**SUBJECT: DEPARTMENT OF THE ARMY PERMIT Number NAN-2012-00090-M5
Originally Issued to New York State Thruway Authority on 25 April 2013 Authorizing
Regulated Work to Facilitate Construction of The New NY Bridge in the Hudson
River between Tarrytown and Nyack, New York**

SUBJECT: Modification to Department of the Army Permit Number NAN-2012-00090-M5 Issued to the New York State Thruway Authority (New NY Bridge Project)

TITLE OF PROJECT	THE NEW NY BRIDGE
LOCATION OF PROJECT	MILEPOST 14.67 +/- IN ROCKLAND AND WESTCHESTER COUNTIES
TITLE OF DRAWING	UNIT 15--ROCKLAND LANDING OUTFALL DETAILS

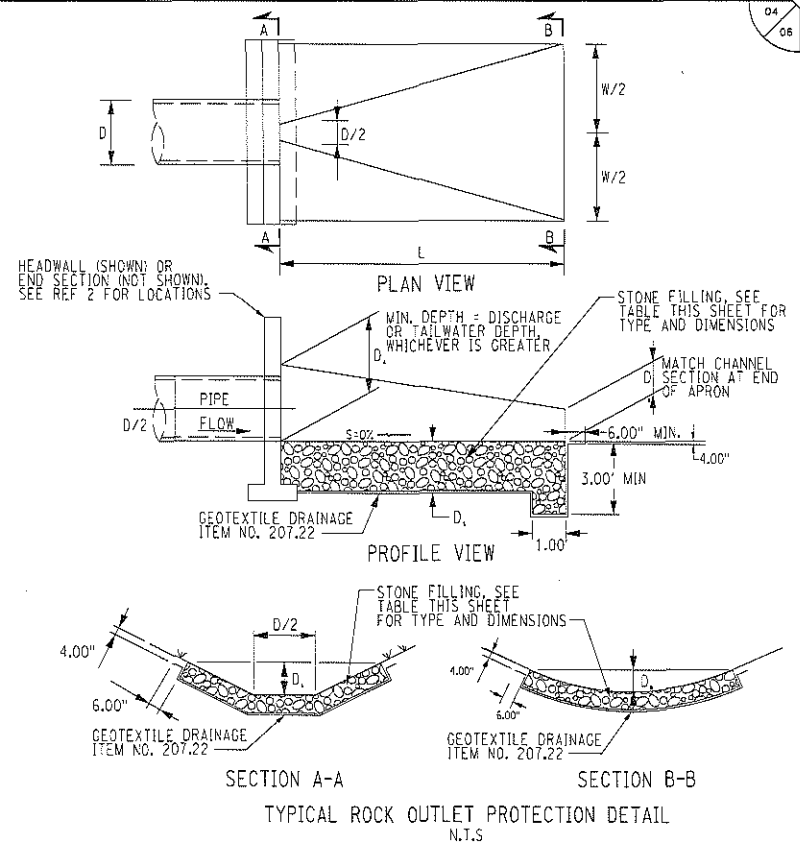
3. The modified regulated work requested at this time includes the replacement of the existing outfall DR-319 (an 18-inch Reinforced Concrete Pipe [RCP] north of the

New York State Thruway) with a 19-inch by 30-inch diameter elliptical RCP, a concrete end section and stone rip-rap outlet protection. The proposed stone fill for DR-319 will impact approximately 202 square feet (sf) of river bottom below the spring high tide line (SHTL).

The existing outfall DR-319 (a 4-foot by 8-foot concrete box culvert south of the New York State Thruway) will not be replaced but stone rip-rap outlet protection will be installed. The proposed stone fill for DR-319 will impact approximately 654 sf of river bottom below the SHTL.
